PETITION FOR SPECIAL HEARING TO THE ZONING COMMISSIONER OF BALTIMORE COUNTY:

IN RE: PETITION SPECIAL HEARING
Beginning at the SW/4 of
Hazy Way Court, 50' SW of
Carroll Island Road
15th Election District
Walter M. Stefanowicz,
Petitioner
* * * * *
BEFORE THE
* ZONING COMMISSIONER
* OF BALTIMORE COUNTY
* Case No. 86-311-SPH

FINDINGS OF FACT AND CONCLUSIONS OF
The Petitioner herein requests approval of an amendment to the 5th Amended Final Development Plan of Carrollwood Manor to substitute six detached, single-family dwellings in lieu of the previously approved 12 townhouses, as more particularly described on Petitioner's Exhibit 1.

6TH AMENDED FINAL DEVELOPMENT PLAN
CARROLLWOOD MANOR
NEW LOTS 1 THRU 6
BLOCK B

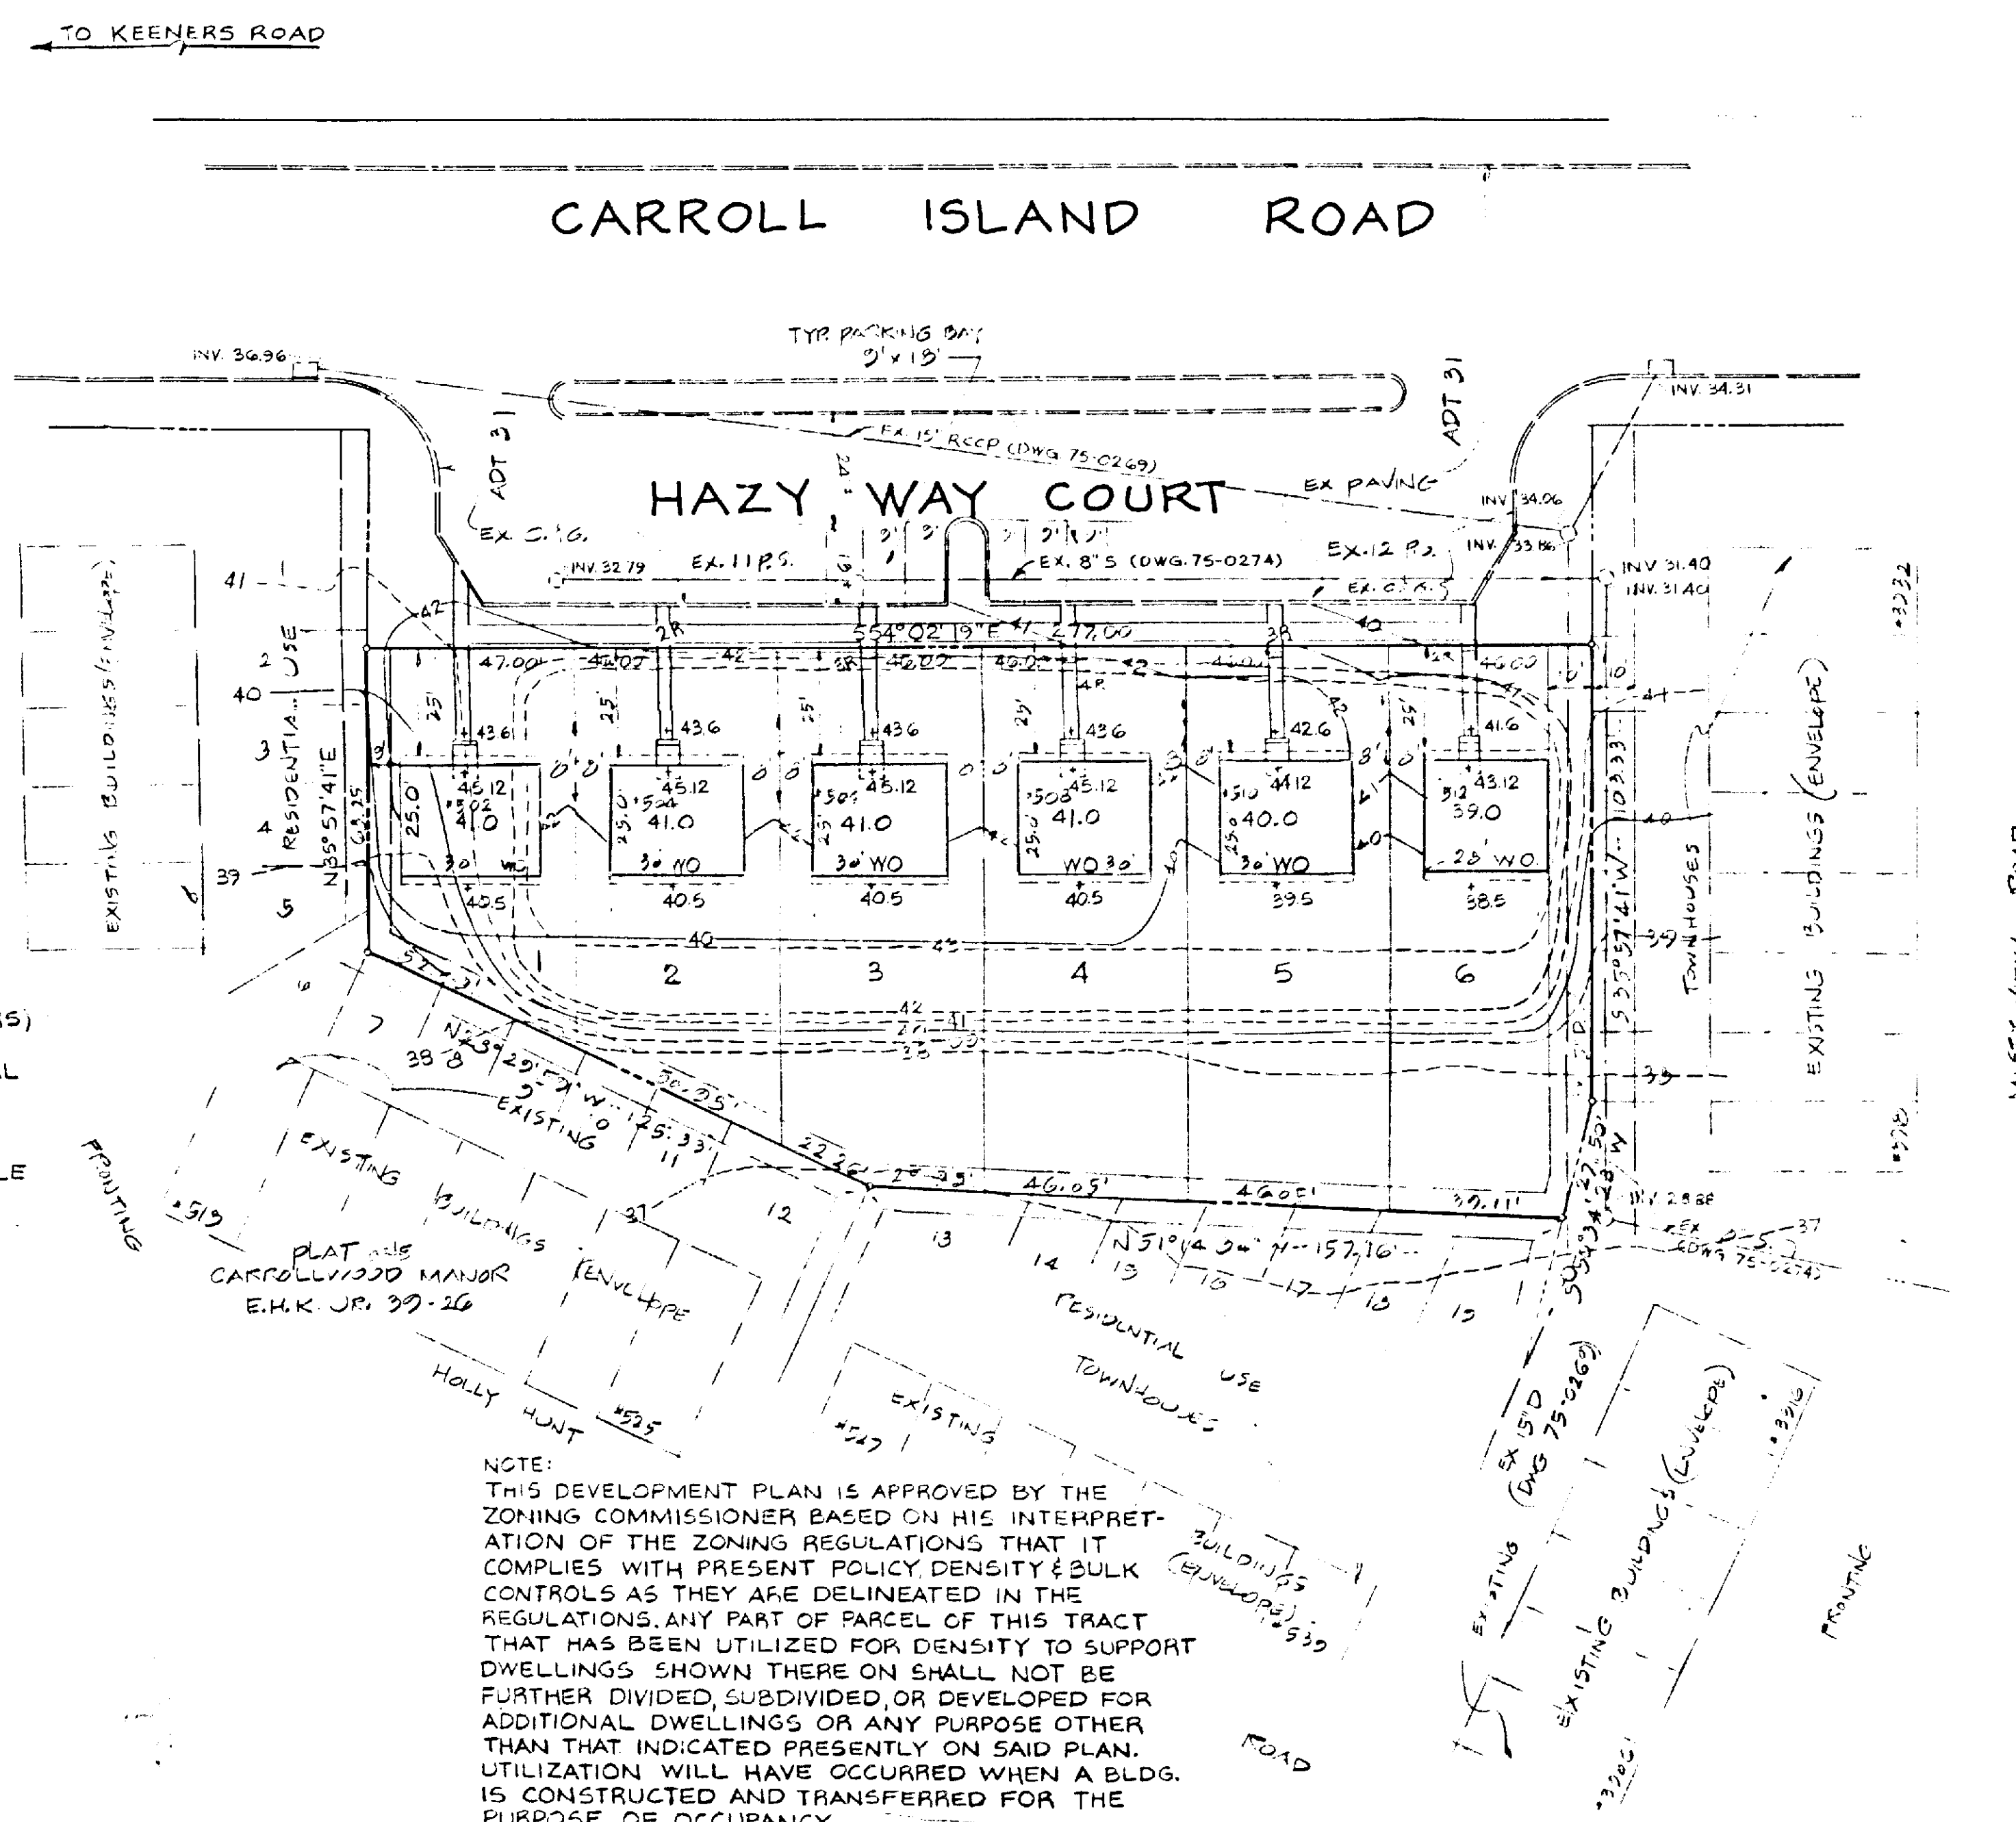
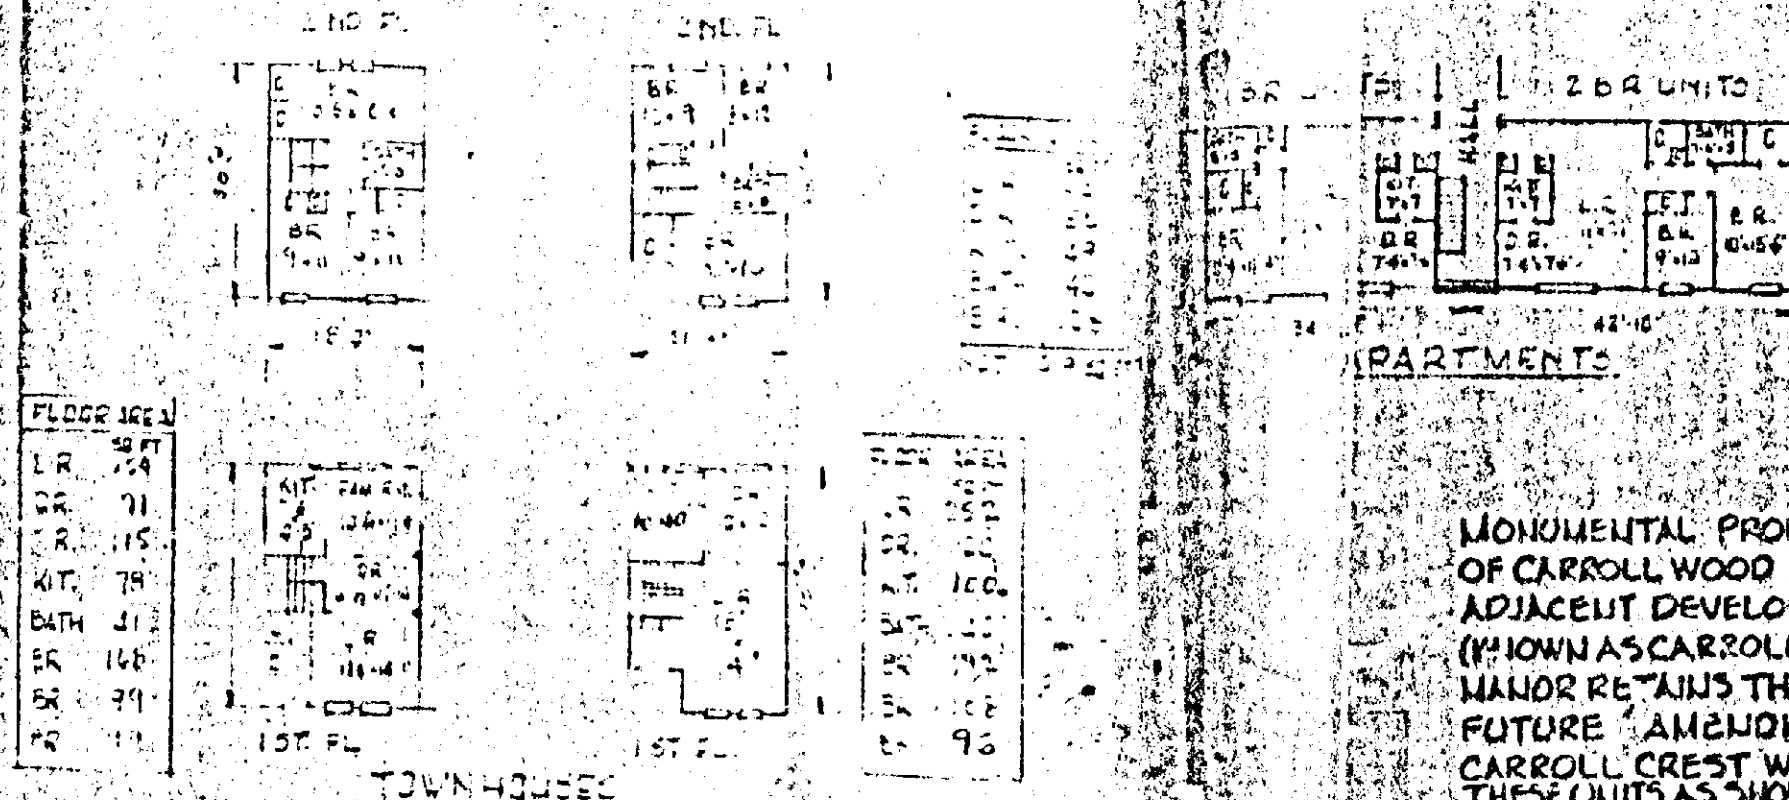
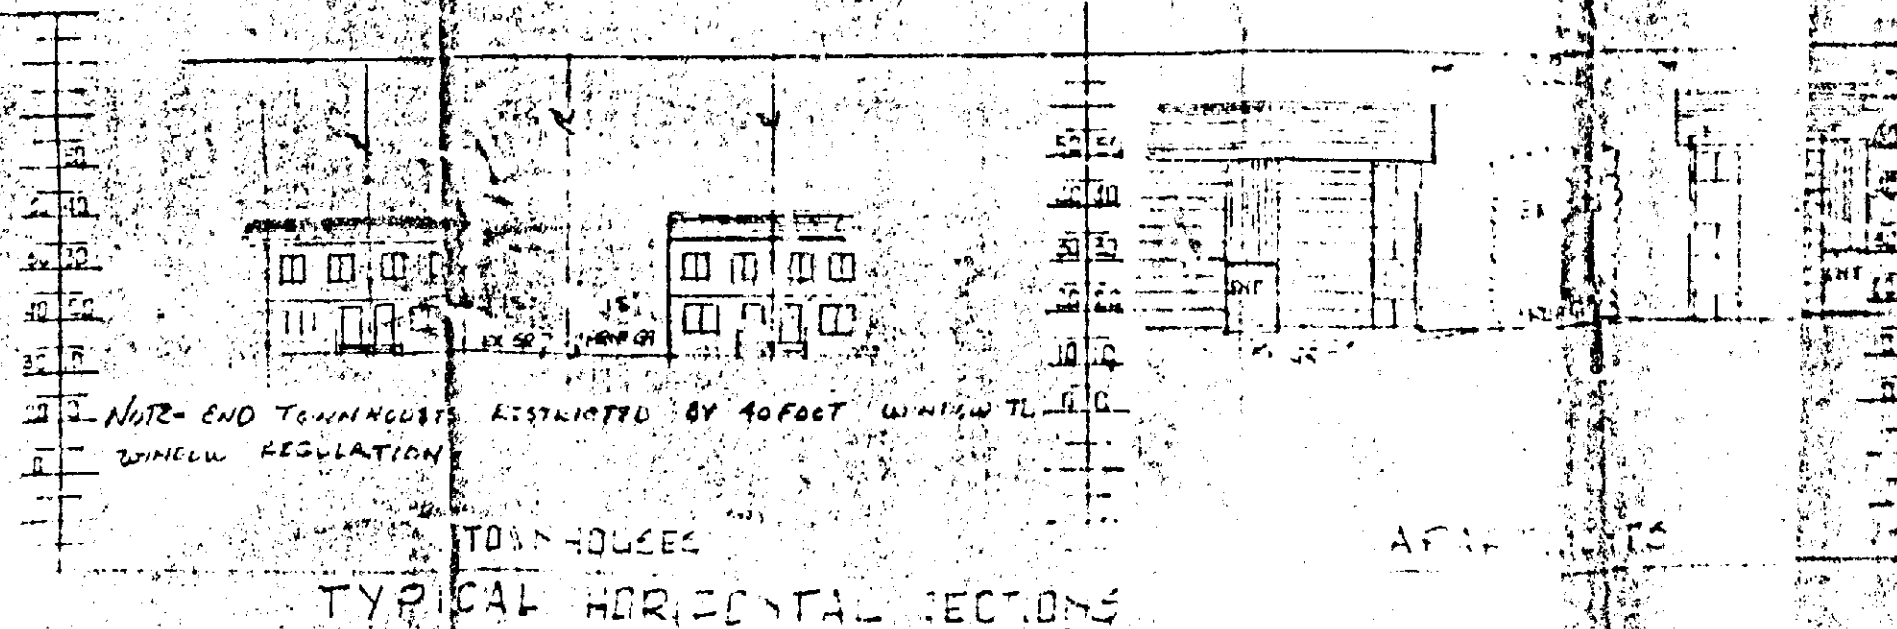
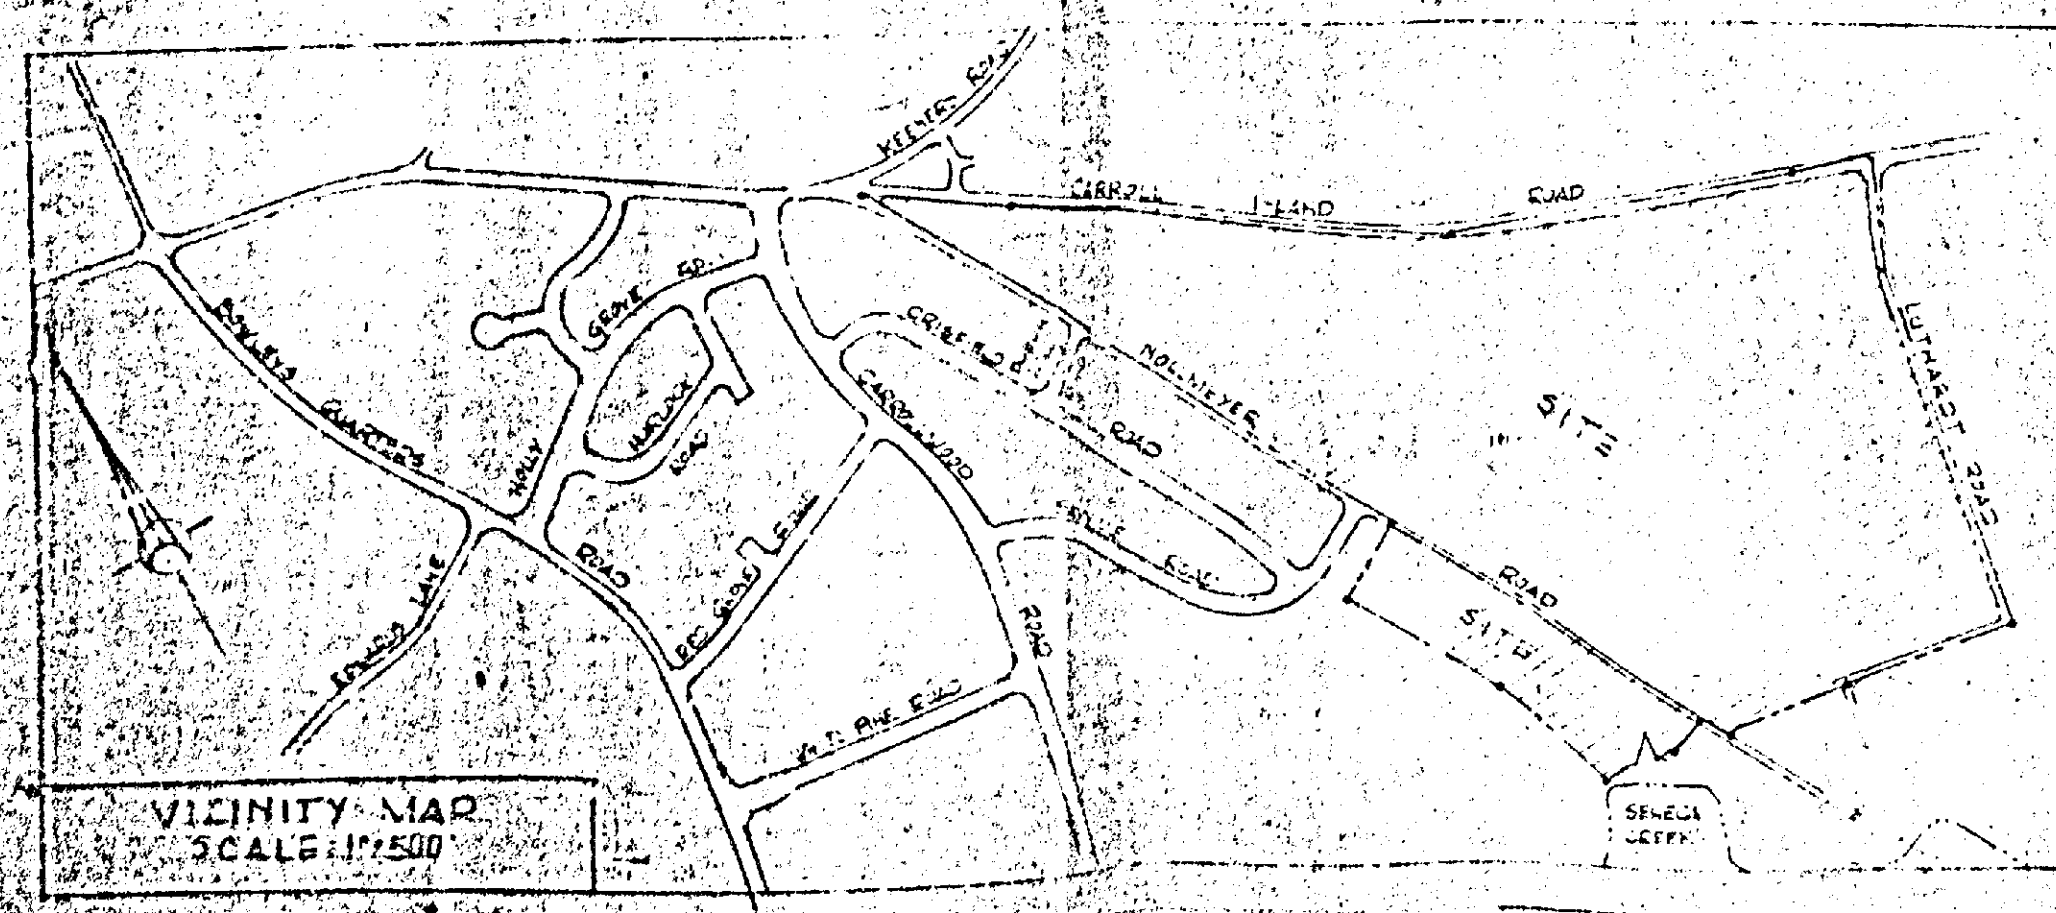
F. The structure does not appear to comply with Table 505 for permissible height/area. Reply to the requested variance by this office cannot be considered until the necessary data pertaining to height/area and construction type is provided. See Table 401 and 505 and have your Architect/Engineer contact this department.

I. The proposed project appears to be located in a Flood Plain, Tidal/Riverine. Please see the attached copy of Section 516.0 of the Building Code as adopted by Bill #17-85. Site plans shall show the correct elevations above sea level for the lot and the finish floor levels including basement.
